Inspection Cover and Gasket Change for XL

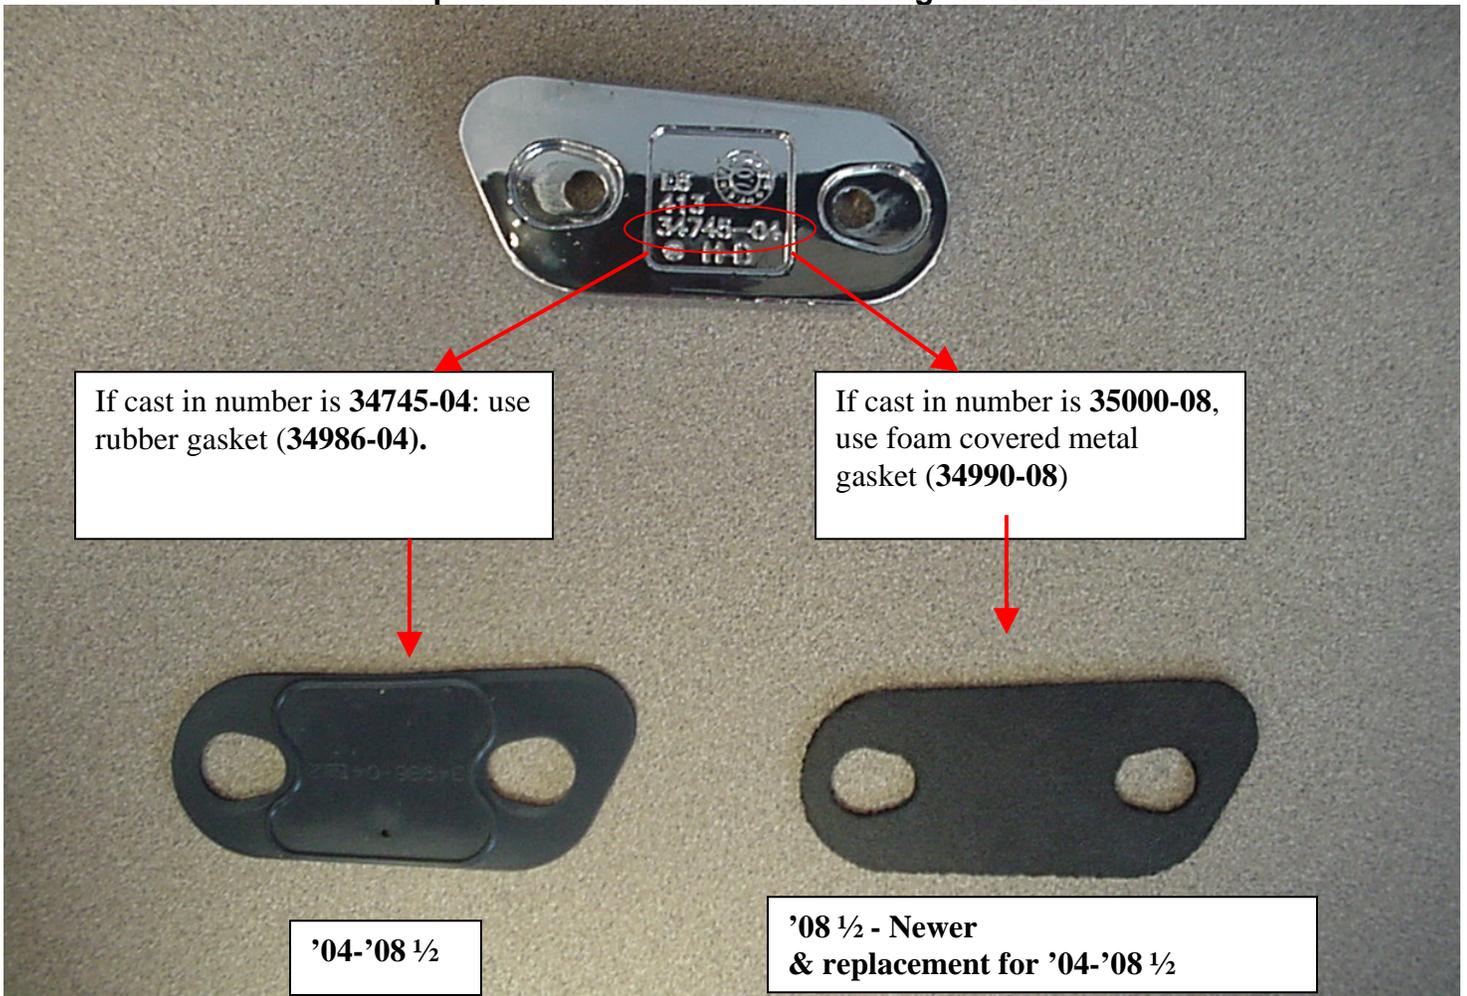
Starting May 5, 2008, All Sportster models received a new inspection cover and gasket as a running change. These new covers and gaskets do retro-fit back to 2004; however, the previous style -04 covers require the use of the previous style rubber gaskets, and the new style -08 covers must be installed with the new style foam gaskets. These parts can be identified visually (see figure above).

NEW P/N	OLD P/N
Gasket Part Numbers		
gasket	34990-08	34986-04
Cover Part Numbers		
polished	34997-08	34993-04
chrome	34998-08	34761-04
black	34999-08	34794-05
Cover Casting Marks		
casting	35000-08	34745-04
Gasket & Cover Service Kits		
For use to service 2004 – early 2008 XL models after your inventory of 34986-04 gaskets is depleted		
Kit polished	34993-04A	n/a
Kit black	34794-05A	n/a
Kit chrome	34761-04A	n/a
